ABOUT ADSP-21364 SILICON ANOMALIES

These anomalies represent the currently known differences between revisions of the SHARC® ADSP-21364 product(s) and the functionality specified in the ADSP-21364 data sheet(s) and the Hardware Reference book(s).

1. 07000005 - Parallel Port Bus Contention:

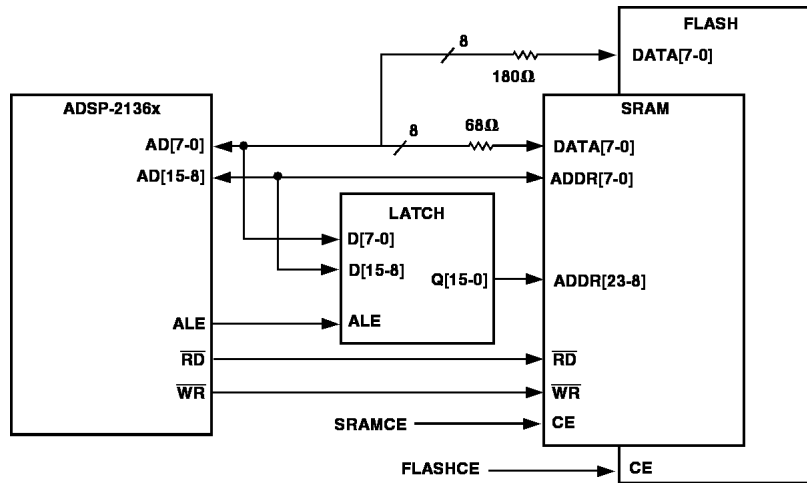
A bus contention issue has been identified on the ADSP-2136x processor's Parallel Port. When crossing an external memory address page while using DMA-READ transfers, an ALE cycle is inserted to update the upper address bits held by the external latch. When the Parallel Port transitions from a Read-cycle to an ALE cycle, insufficient time was provided to allow the external SRAM or FLASH to tri-state its bus. The bus tri-state from /OE de-assertion timing is typically longer for Flash than for SRAM devices, this necessitates a separate examination for both the SRAM and FLASH cases.

Memory Read—Parallel Port 16-Bit:

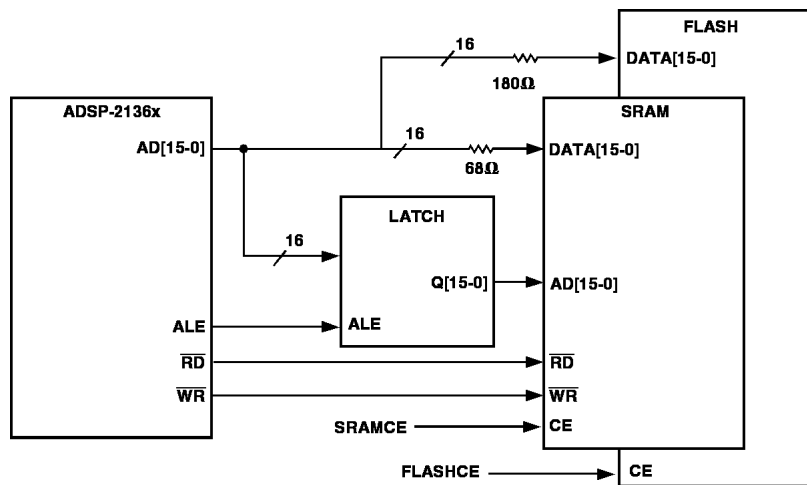
A typical 8ns SRAM will require 5-7ns to tri-state from /OE de-assertion. The ADSP-2136x only provides for approximately 4.0 ns; therefore, a 3.0ns contention possibility exists. At this time the recommended work-around is to place series resistors before the SRAM data lines, as shown in the diagram below. This resistor will limit the maximum pin current to about 22mA, while still providing sufficiently fast rise-fall rates to meet timing requirements. Our recommendation is 68-Ohms. This option will operate at full speed and require no software changes.

7. 0700011 - SPI can generate spurious clock for an additional word when used in receive DMA mode at maximum SPICLK frequency:

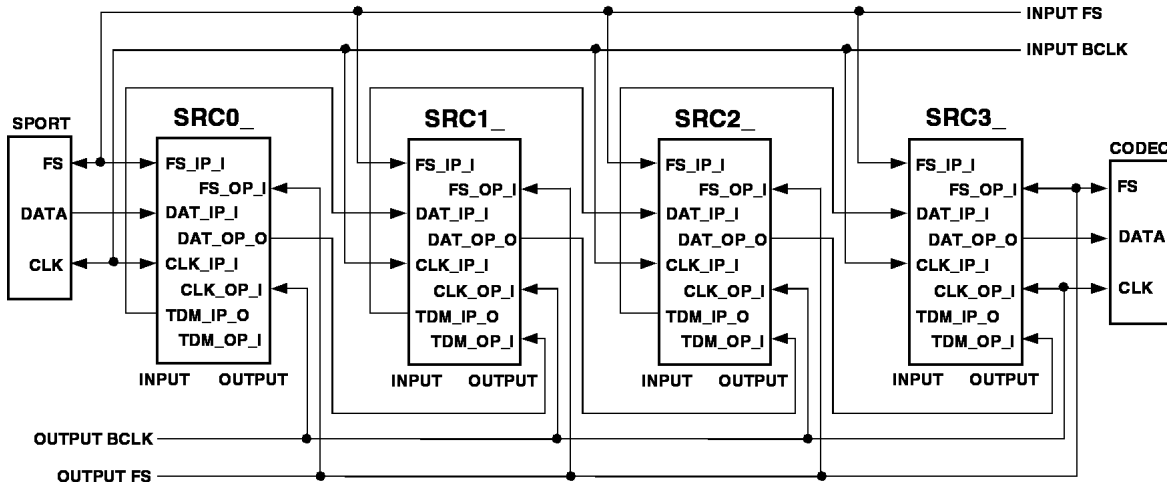
1. The SPI is configured for 32-bit, receive master DMA mode and performs back to back DMA transfers.
2. The SPI DMA is disabled and re-enabled between back to back DMA transfers without disabling the SPI itself.
3. The SPI is operated at the maximum SPICLK frequency (SPIBAUD = 2).

When the above three conditions are met, SPI can generate clock for an additional word even after the FIFO and the receive buffer is full. This clock for another word can cause the receive buffer overflow error which will result in loss of the additional received data word.

1. Do not disable the SPI DMA between back to back DMA transfers.
2. If the application demands disabling SPI DMA between back to back DMA transfers then the sequence given below must be followed:
 - Disable the SPI DMA
 - Disable the SPI
 - Clear the FIFO and the receive buffer
 - Configure the DMA descriptors and Enable the SPI
 - Enable the SPI DMA
